INDESIT company

Model type:
AVSF109SIT

Commercial code:
F033138

Fig . 001

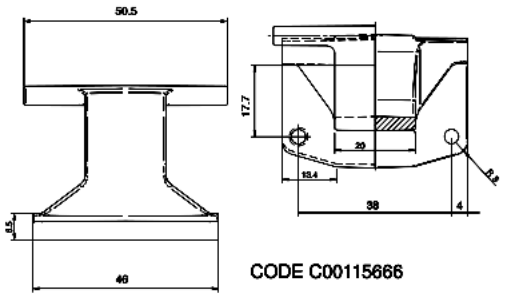
n1040349: Introduction of 150° Zamac hinge on Ariston 46 models.

From serial no. 50207.0001, all Ariston models produced in the Teverola factory (see table 001 attached) with industrial code (given on the rating plate) starting with 46, have been equipped with a Zamac hinge with 150° opening angle, code C00115666

(see Fig.001).
This modification has involved the introduction of the following items:

Code C00115670 - Complete door EVOII 150° white 27 with standard glass;
Code C00115674 - Complete door EVOII 150° white 27 with long glass;
Code C00115667 - EVOII body for 150° hinge white 27;

The premodified items are not interchangeable separately with the modified ones.

Code C00110133 - Complete door EVOII Standard 180° white 27 standard glass;
Code C00092157 - Complete door EVOII 180° white 27 long glass;
Code C00096193 - EVOII body for 150° hinge white 27;

The hinge code C00064541 continues to be used on the build-under models produced in the Comunanza factory.

Fig . 001

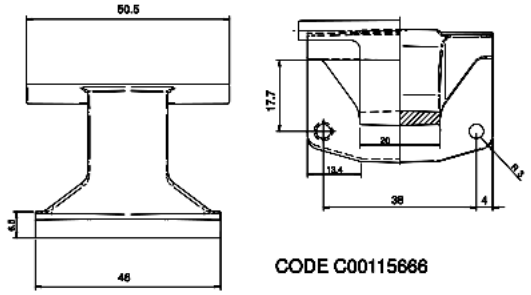
n1040353: Introduction of 150° Zamac hinge on Ariston models (Comunanza).

From serial no. 50207.0001, all Ariston models produced in the Comunanza factory (see table 001 attached) with industrial code (given on the rating plate) starting with 80, have been equipped with a Zamac hinge with 150° opening angle, code C00115666 (see Fig.001).
This modification has involved the introduction of the following items:

Code C00115670 - Complete door EVOII 150° white 27 with standard glass;
Code C00115674 - Complete door EVOII 150° white 27 with long glass;
Code C00115668 - Complete door EVOII 150° silver with standard glass;
Code C00115673 - Complete door EVOII 150° silver snella standard glass;
Code C00115662 - EVOII body for 150° hinge white 27
Code C00115663 - EVOII body for 150° hinge silver 27
Code C00115664 - Snella EVOII body for 150° hinge white 27
Code C00115665 - Snella EVOII body for 150° hinge silver

The premodified items are not interchangeable separately with the modified ones.

Code C00096416 - Complete door EVOII LB 180° standard depth silver;
Code C00097374 - Complete door EVOII 180° WD 180° white 27 long glass;
Code C00110133 - Complete door EVOII Standard 180° white 27
Code C00110178 - Complete door EVOII Snella 180° Silver;
Code C00091836 - EVOII body white 27 for 180° hinge;
Code C00094306 - EVOII body silver for 180° hinge;
Code C00094305 - Snella EVOII body white 27 for 180° hinge;
Code C00094307 - Snella EVOII body silver for 180° hinge;

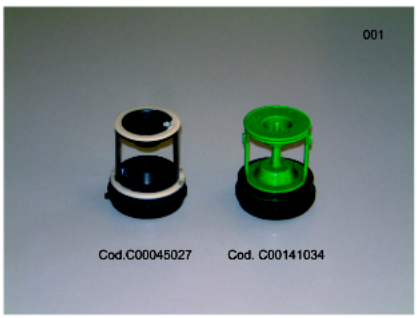
n1040376: Drain pump with filter with pin.

A new drain pump with filter with pin has been introduced progressively as from serial no. 50609.0001.

New parts:
C00119307 - Drain pump with pin filter;
C00141034 - Askoll / Plaset drain pump with pin filter kit (figure 001);

Premodification parts:
C00092264 - Drain pump;
C00045027 - Askoll / Plaset pump filter kit (figure 001);

The new parts can be used on all WASHING MACHINES previously equipped with the premodification parts.
